**NOTICE
OSHTEMO CHARTER TOWNSHIP
PLANNING COMMISSION**

**Regular Meeting
Thursday, February 28, 2019
6:00 p.m.
AGENDA**

Request: Site plan review approval

Project Name: Advia Credit Union Corporate Headquarters

SITE PLAN
1"=50'-0"

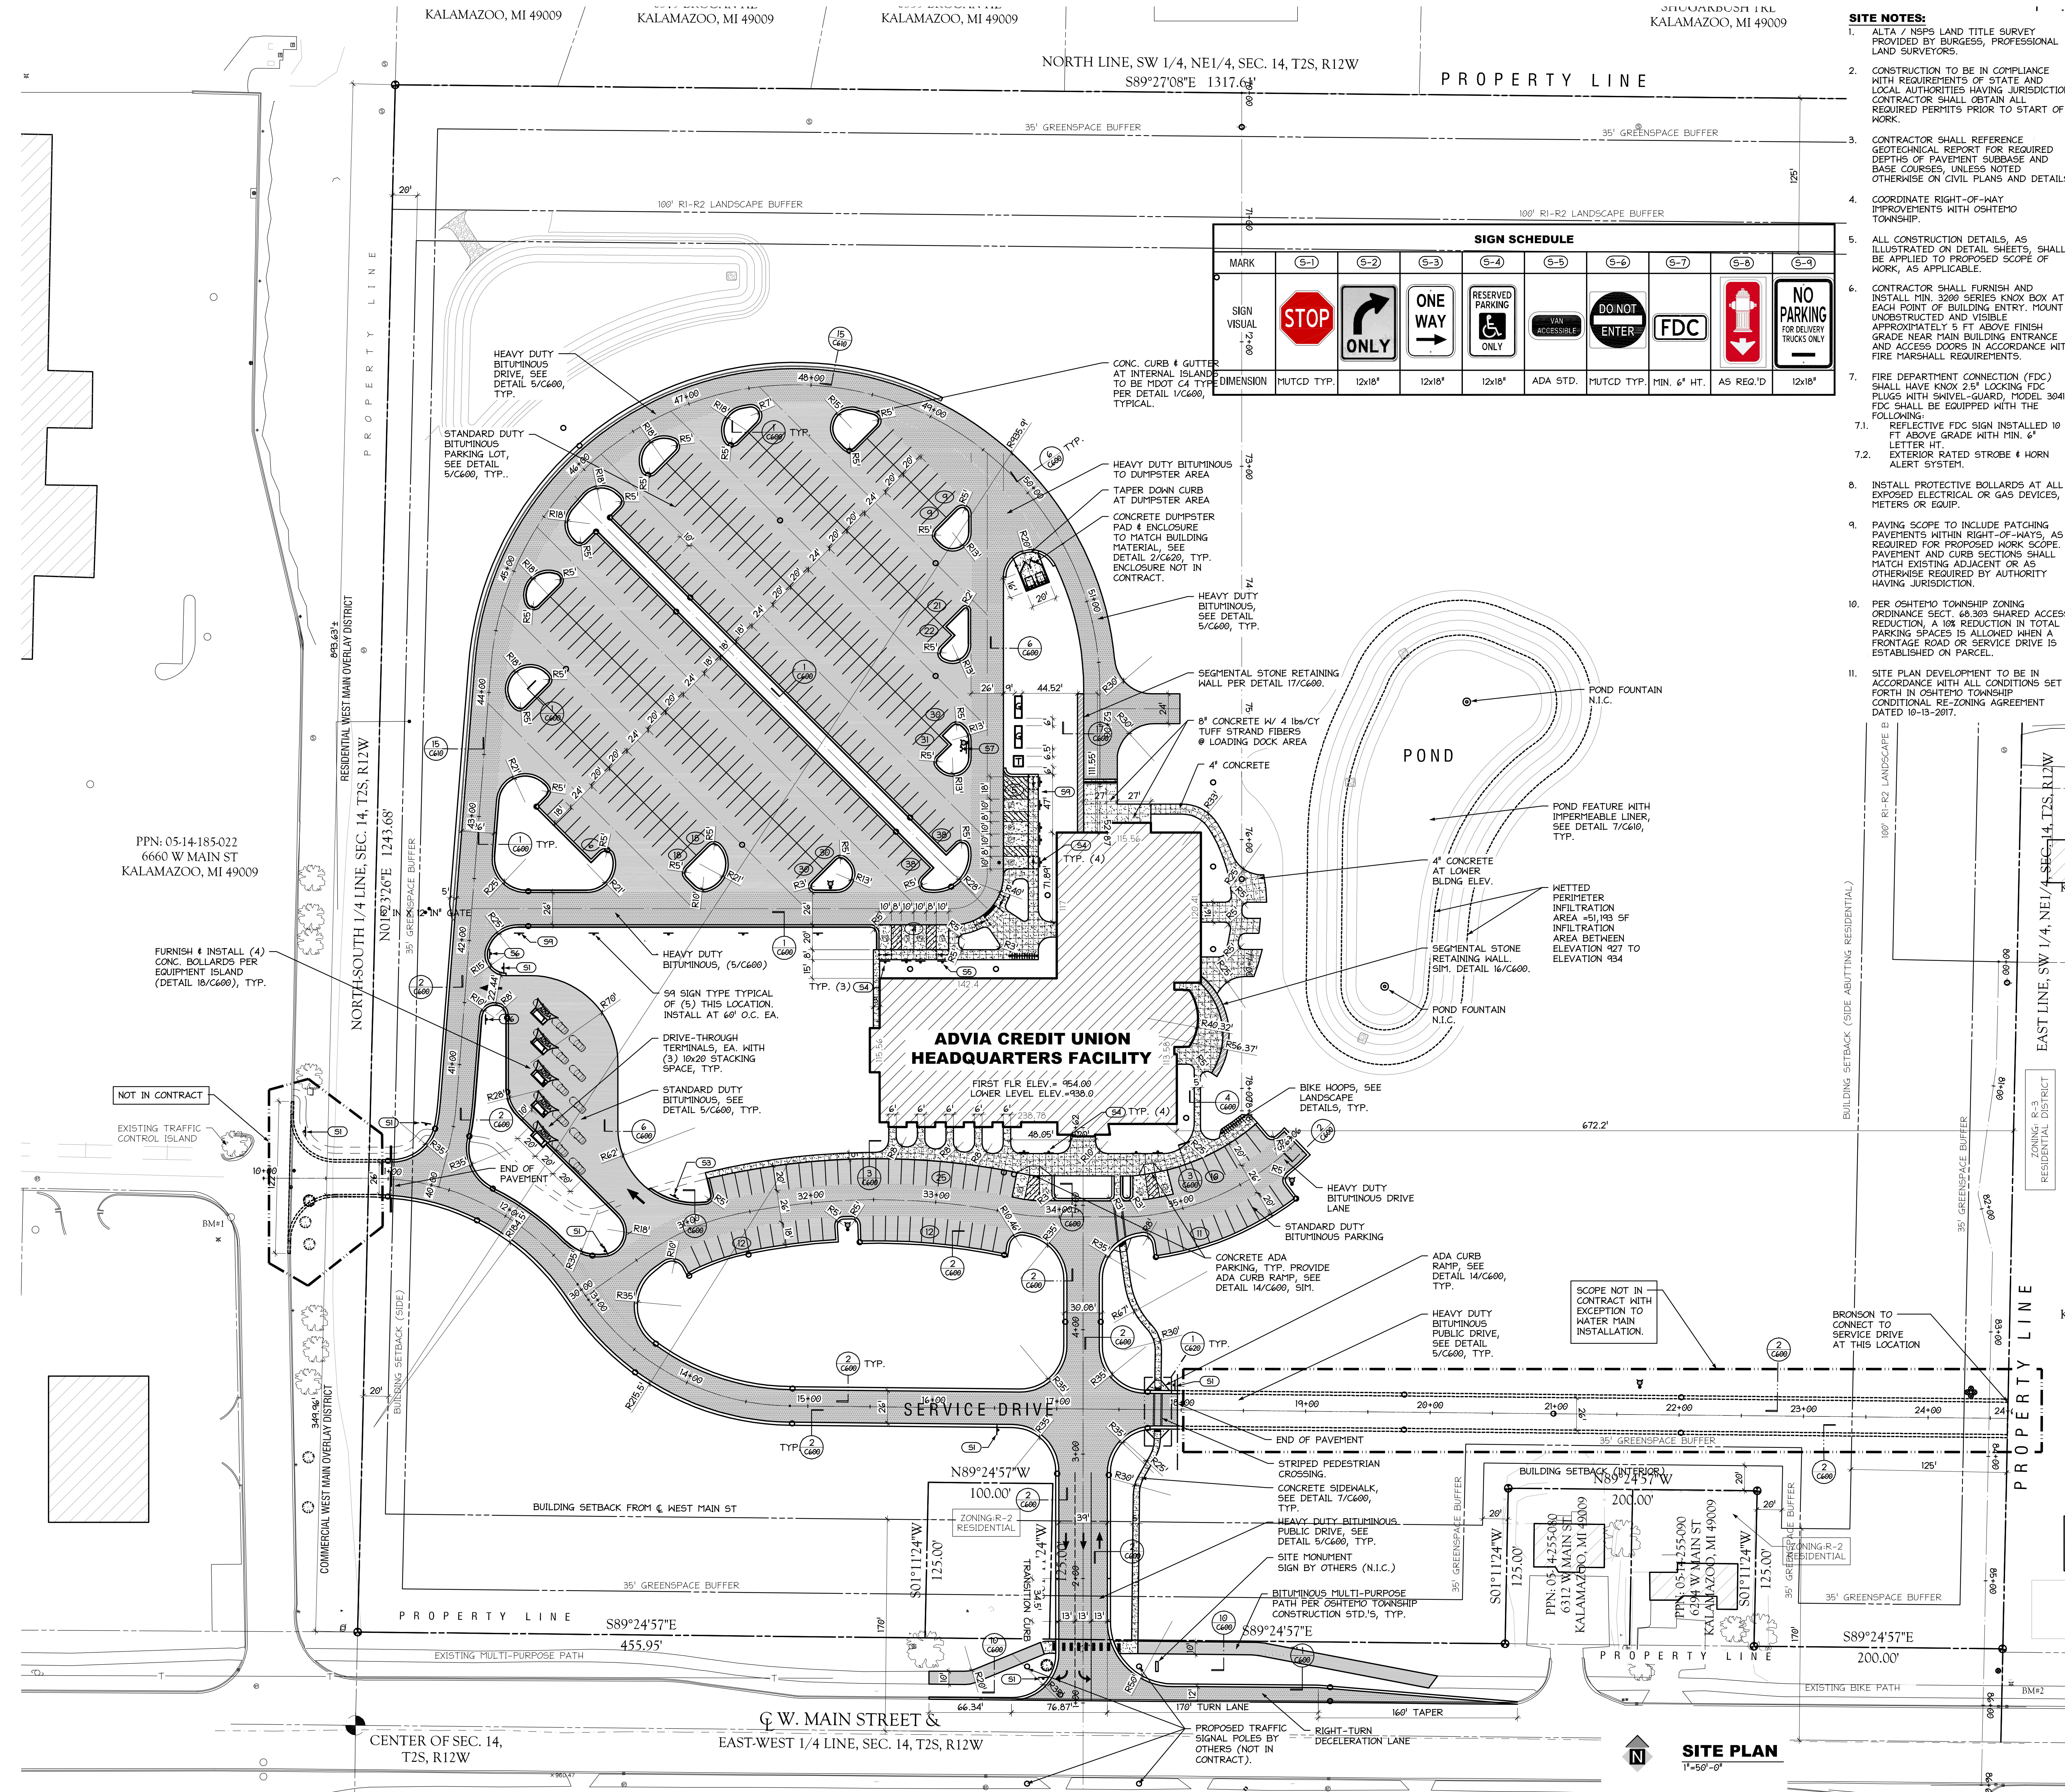
In general, the site plan meets the Zoning Ordinance requirements for parking, drive aisles within the parking area, handicap accessible spaces, drive through teller windows, and a nonmotorized connection to the 10-foot multi-use path along West Main Street. Of note, the applicant is utilizing *Section 68.300.A*, which allows parking lots over 100 spaces to reduce the size of 25 percent of the spaces. Of the 378 planned parking spaces, 93 will be sized at 10 feet by 18 feet as opposed to the standard 10-foot by 20-foot space.

A nonmotorized connection is shown on the site plan (sheet C200) to the west. It is a dashed line from the front parking lot through the drive through lane drive aisle to the west property line. This connection is shown a little differently on the landscape plan (sheet L100). Staff would recommend removing the connection from the site plan to be consistent with the eastern nonmotorized connection, which is shown on the landscape plan not the site plan. In addition, the nonmotorized path should extend to the property line.

The following rezoning conditions are outlined on sheet C200, Site Plan. Staff's comments are outlined below each condition.

The applicator is providing a service drive that is intended to connect to the neighboring properties to the east (Bronson) and west (Meijer). The access to the east has been indicated on the site plan to be developed in the future. This is due to the unknown development plan for the Bronson property. *Section 50.402* of the West Main Overlay Zone indicates where adjacent properties have not yet developed and/or extensions of the interior street system abutting the site has not yet been constructed, provision can be made for future site design that accommodates the interior street system. However, because this is a requirement of the conditional rezoning, staff would recommend having a signed agreement between Advia and Bronson ensuring this future connection will occur.

The connection to the west has been designed to the property line, but the connection to the Meijer drive is shown as "not in contract." At the time of this memo, a cross-access agreement between Advia and Meijer has not been resolved. The area shown as "not in contract," is located on the Meijer property, but will need to be completed to ensure cross access between sites. The Planning Commission will need to determine whether to condition the site plan to ensure the access is achieved.

Finally, a condition of approval is that the site be accessed from West Main Street at a signalized intersection. The site plan indicates "proposed traffic signal poles by other." Staff's understanding is that MDOT has approved the traffic signal at this location. However, it is unclear from the site plan who will be installing the light. Staff has an inquiry into MDOT requesting confirmation that the signal has been approved and who will ensure the installation. At the time of this memo, we have not received a response.

- Staff is recommending the dashed line that outlines the western nonmotorized path on the site plan be removed and the nonmotorized network be displayed on the landscape plan. In addition, the path should extend to the western property line.

1. Cross access agreements must be signed between Advia and the neighboring properties to the east and west. The service drive connections must be constructed to the west prior to the issuance of a certificate of occupancy and to the east after development approval of the Bronson site.
2. The dashed line that outlines the western nonmotorized path on the site plan be removed and the nonmotorized network be displayed on the landscape plan. In addition, the path should extend to the western property line.
3. Confirmation from MDOT that the signal has been approved and who will be responsible for installing the infrastructure.

1700181
EC100
ELECTRICAL SITE PLAN

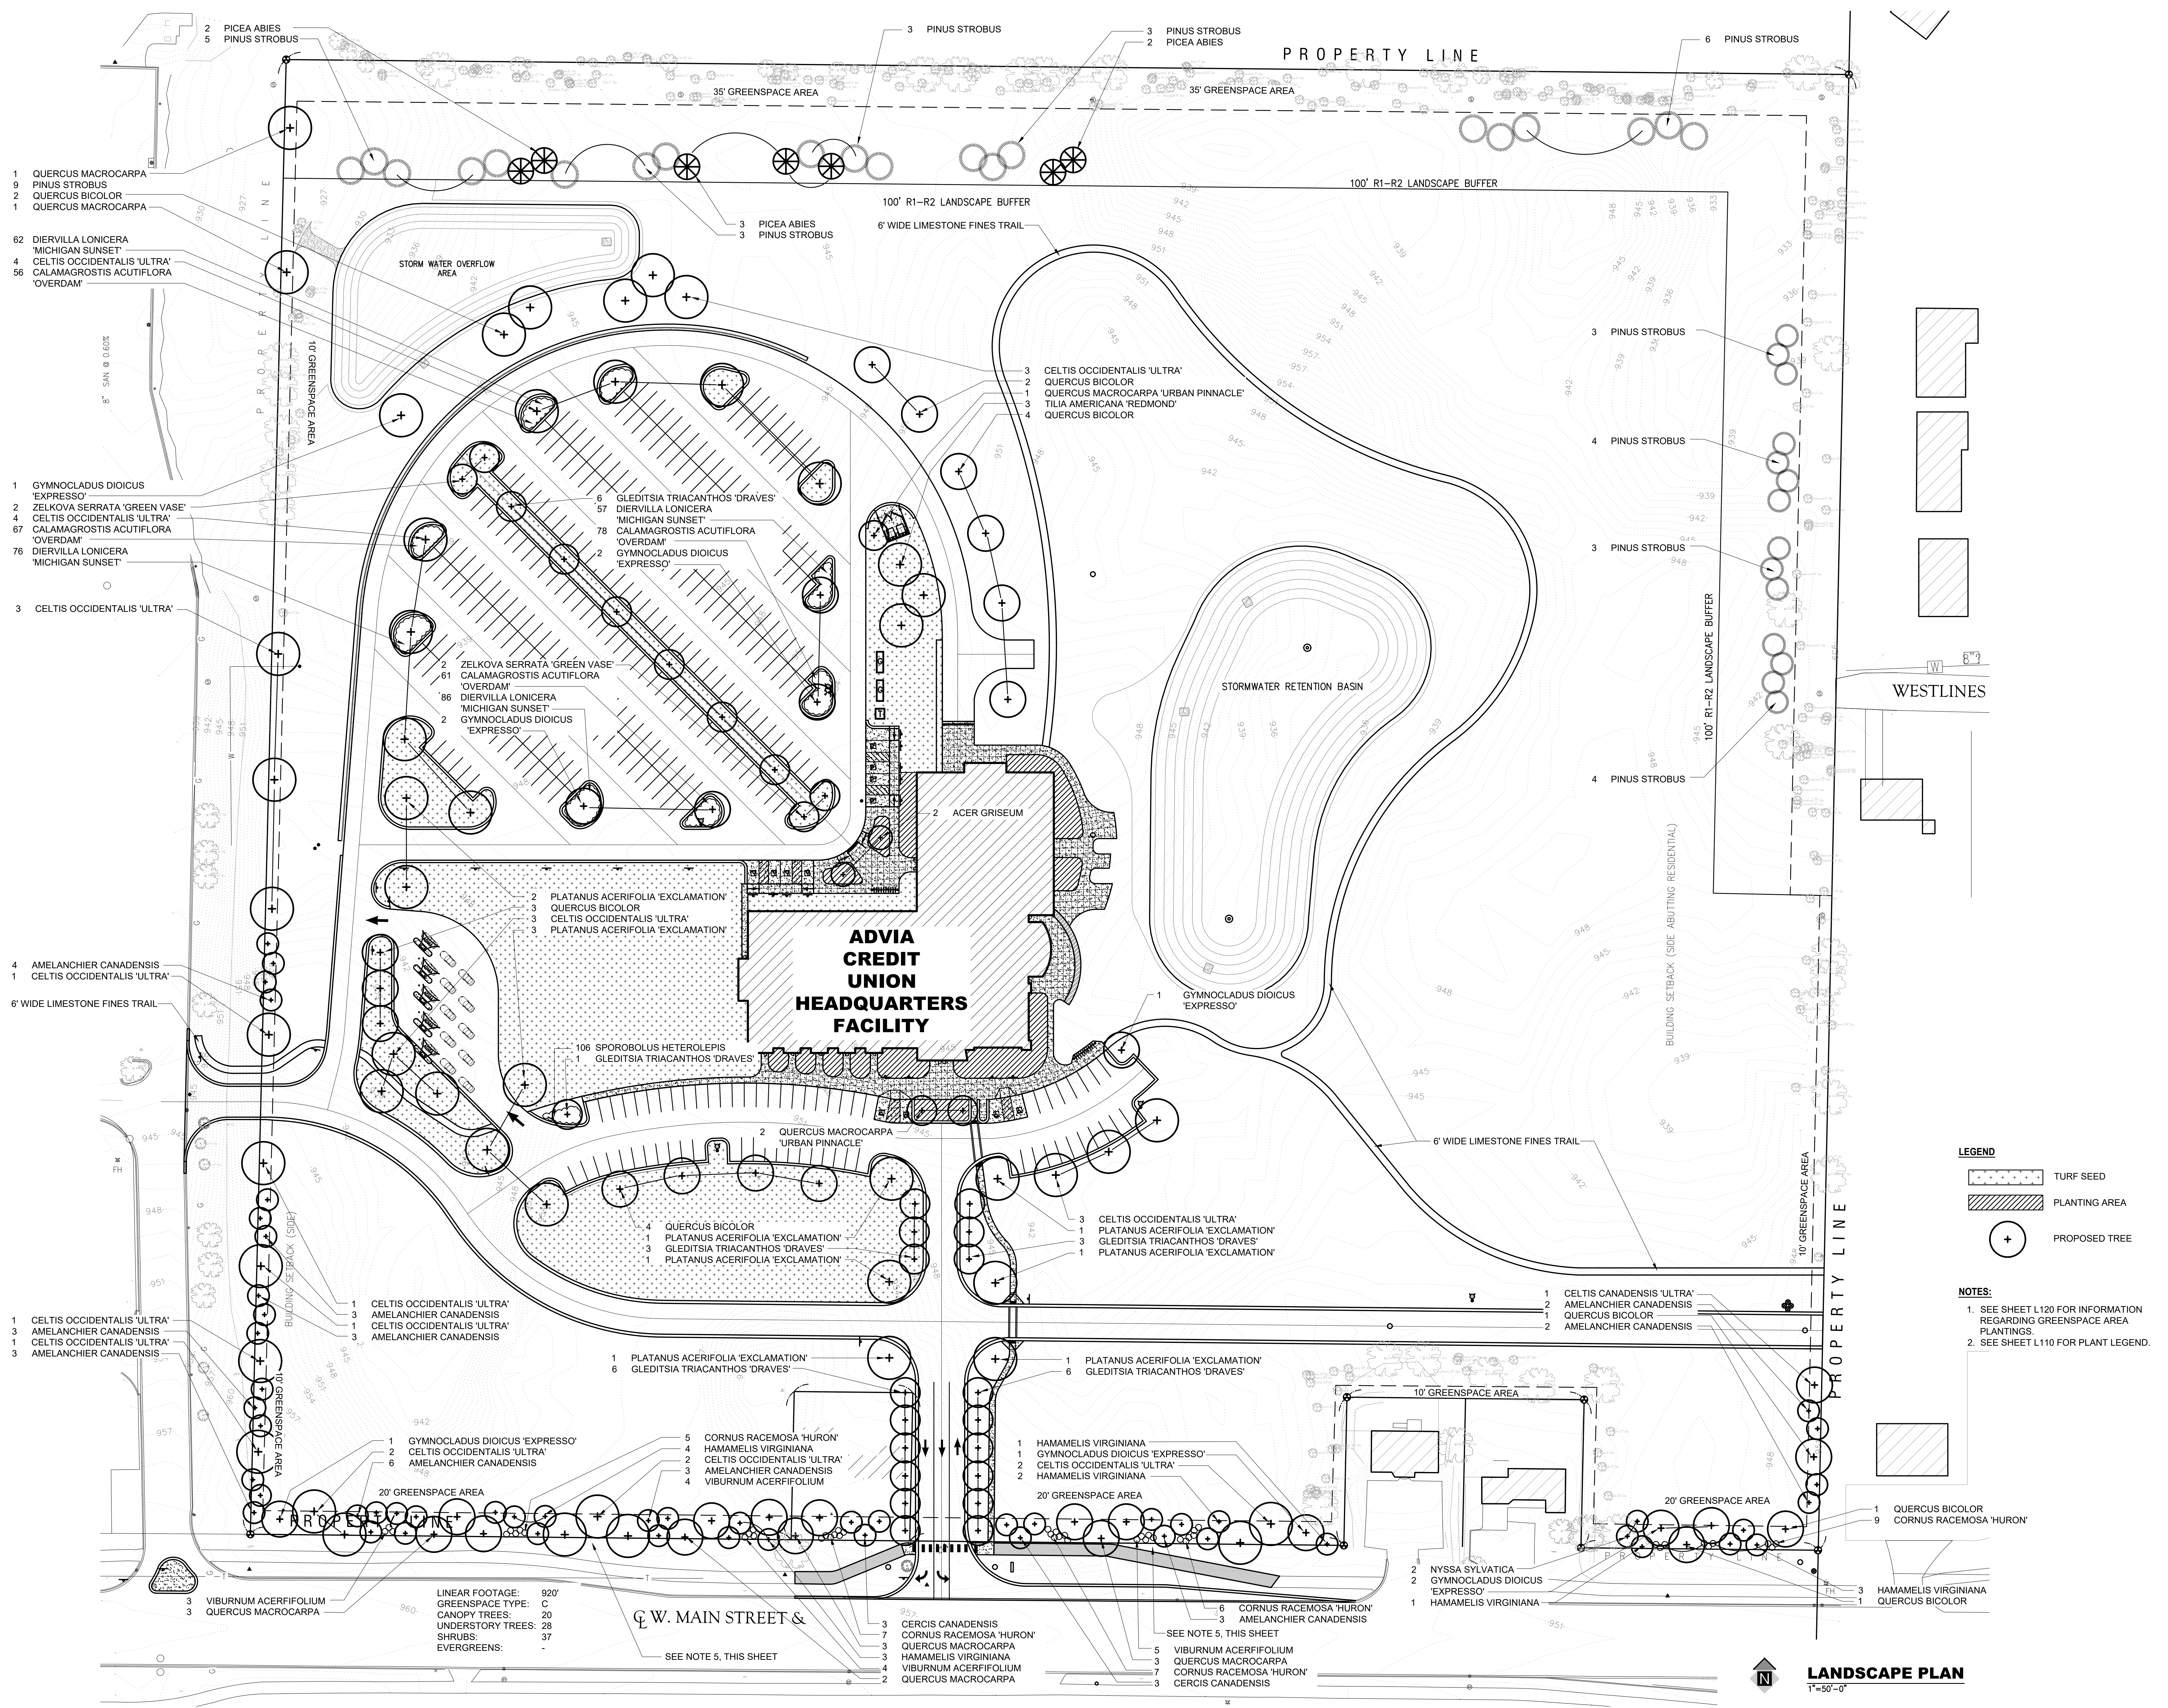
Per *Section 78.720.A*, lighting levels are required to be at 0.1 foot-candles at the property line. The photometric plan shows a lighting level of 0.4 to 0.7 at the property line near the drive aisle entrance to the site. The lighting design for this area will need to be altered to ensure the required 0.1 foot-candle requirement.

In addition, the photometric plan indicates building mounted and architectural pole lighting on site. However, specifications of these fixtures have not been provided to ensure they are full cut-off and downward directed. Staff would recommend a note being placed on the photometric plan which states all lighting will be full cut-off and downward directed. Also, lighting is required to be reduced during non-operational hours, allowing only lighting necessary for security purposes. The photometric plan should note where this distinction will occur.

- The lighting specifications for the building and architectural pole lighting needs to be provided to the Township. In addition, a note should be placed on the photometric plan that all lighting will be full cut-off and downward directed. Finally, information needs to be included on the photometric plan related to reduced lighting during non-business hours.
